Amendments to the Drawings:

Attachment: Replacement Sheet
Annotated Sheet Showing Changes

Fig. 4

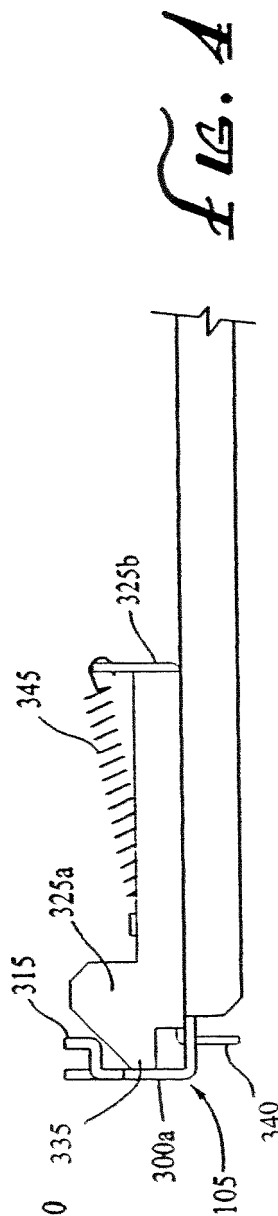
The attached sheet of drawings includes changes to Figs. 4-6. This sheet, which shows Figs. 3-6, replaces the original sheet showing Figs. 3-6. In Figs. 4-6, the element previously labeled “405” has been relabeled “340,” and in Fig. 4, the element previously labeled “400” has been relabeled “335” to conform to the specification. A marked-up annotated copy of the amended drawings is also attached.
